#2019-113

**Raising Canes – Preliminary and Final PUD
Project Review for Planning and Zoning Commission**

<u>Meeting Date:</u>	May 6, 2020 public meeting and May 20, 2020 public hearing
<u>Request:</u>	Preliminary and Final Planned Unit Development for a new 3,316 square-foot limited service restaurant.
<u>Location:</u>	5417 Northwest Highway
<u>Acreage:</u>	Approximately 1.15 acres
<u>Existing Zoning:</u>	B-2 PUD General Commercial Planned Unit Development
<u>Surrounding Properties:</u>	North: B-2 PUD General Commercial South: M Manufacturing (Three Oaks Recreation Area) East: B-2 PUD General Commercial West: B-2 PUD General Commercial
<u>Staff Contact:</u>	Elizabeth Maxwell (815.356.3615)

LANDSCAPE PLAN
DATE 03/06/2020
JOB NO. 19101
L1.0
SHEET NO.

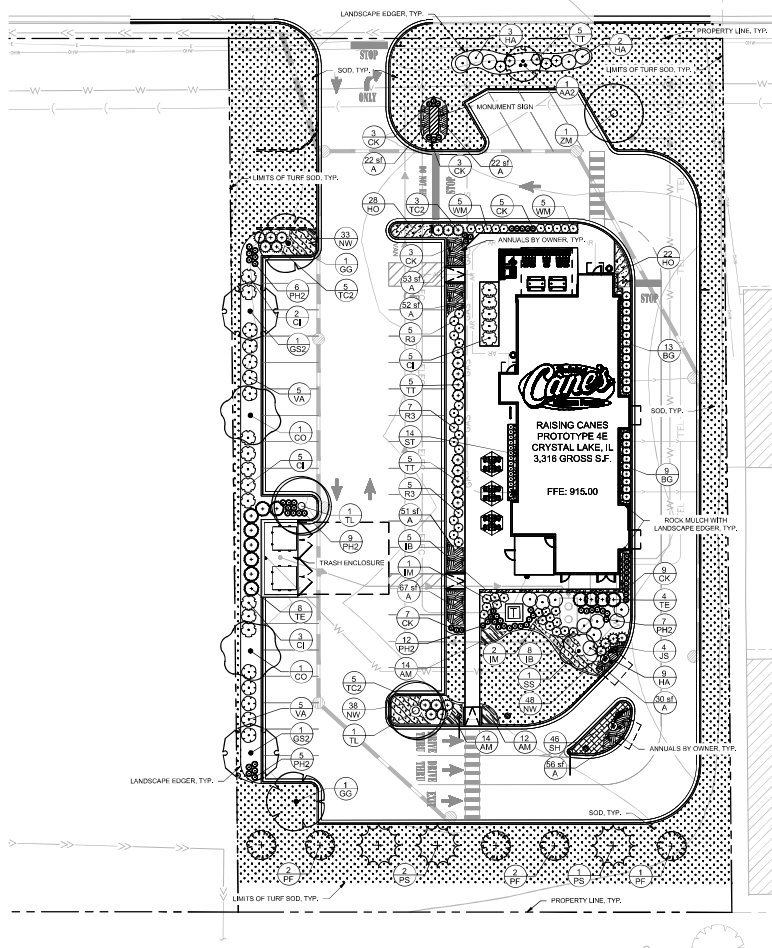
- B. Provide a sidewalk along the frontage of the lot.
3. Landscape Plan
 - A. Add a tree and 5 shrubs to the landscape end island just to the east of the monument sign.

- B. Add some landscape shrubs along the curve of the drive-through to screen any headlights exiting the drive-through to Route 14.
4. Elevations
 - A. Remove all cove lighting or illuminated banding around the building.

1 NORTH ELEVATION
A4.10 SCALE: 1/4" = 1'-0"

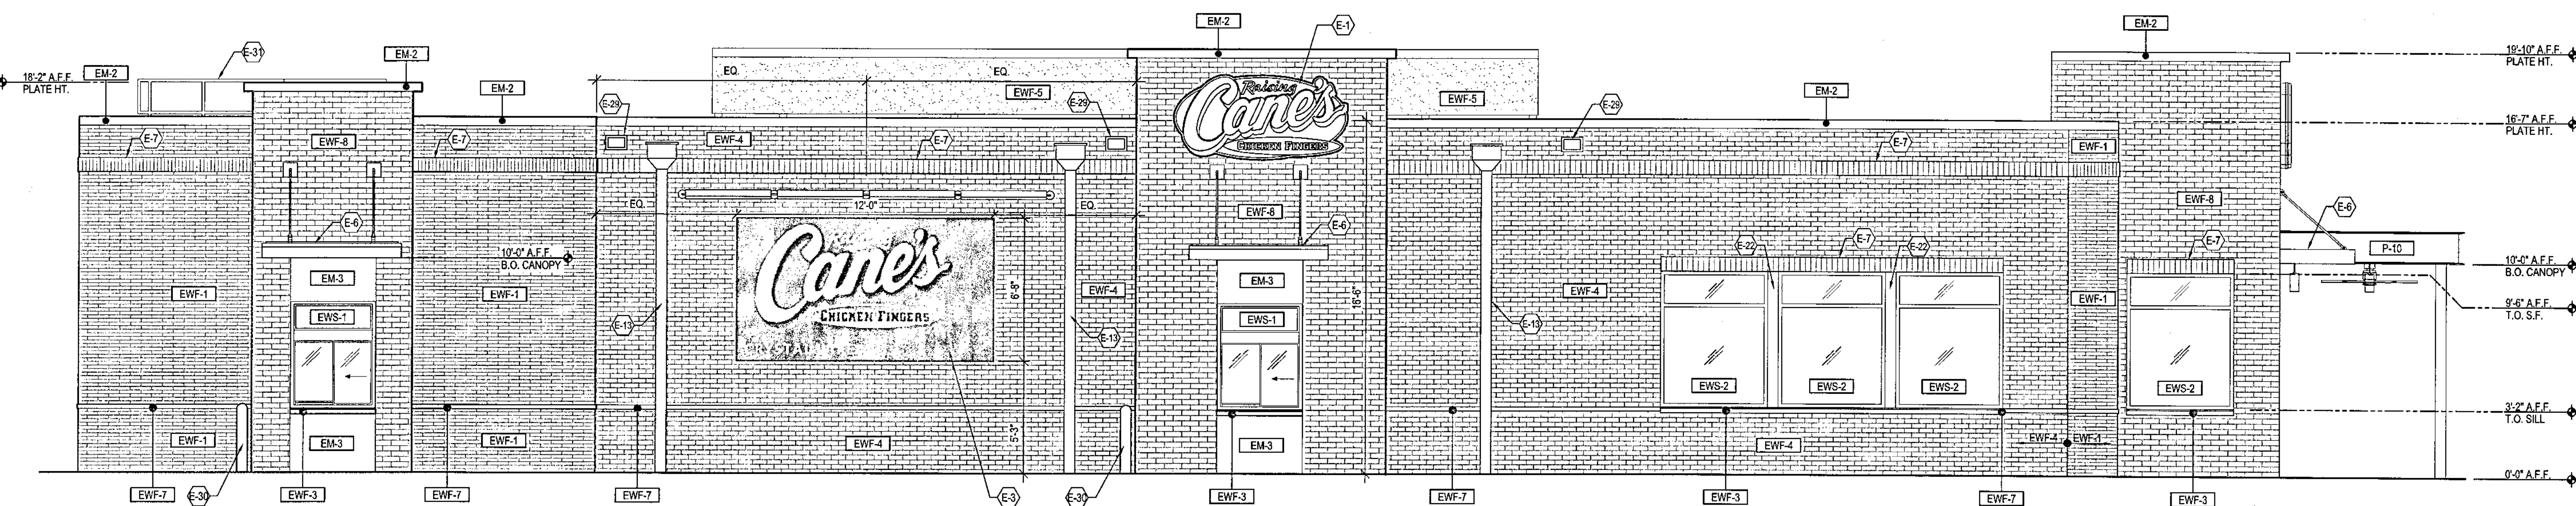
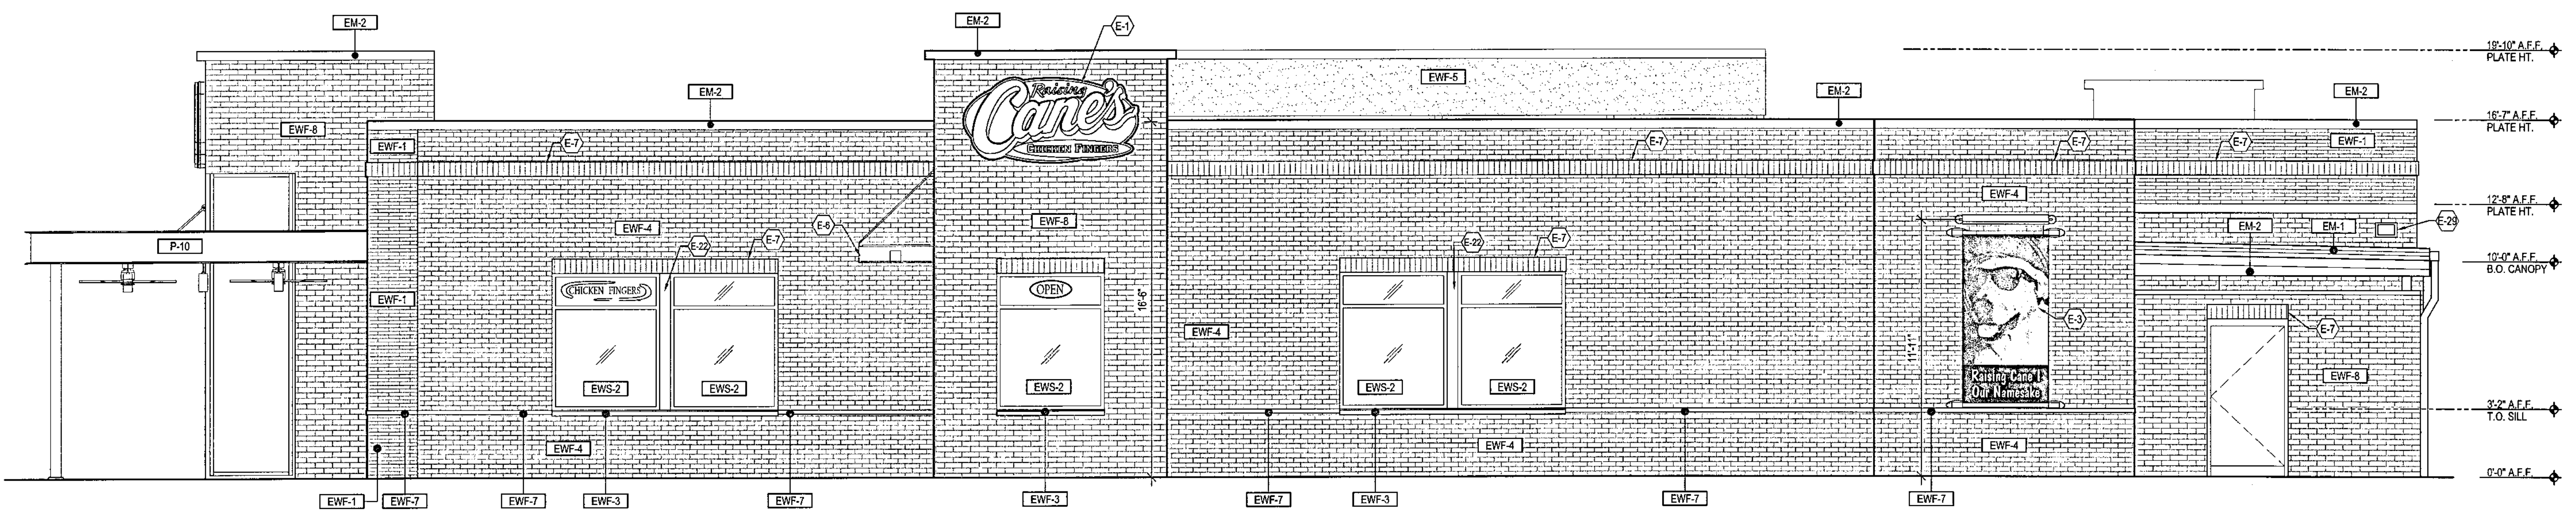
- Banding of soldier course brick defines the top portion of the façade and is found above the doors and windows.
- Dark awnings, metal framed windows and doors and metal top cap provide additional accents around the building.
- Staff has reviewed the elevations based on the criteria listed in the Design Standards. The project meets 8 of the 10 criteria with one being no and one being not applicable. Six of 10 are required to be considered meeting the design standards for architecture.
- Illumination is not permitted to outline portions of the building, the cove lighting shall be removed and a condition of approval has been added.
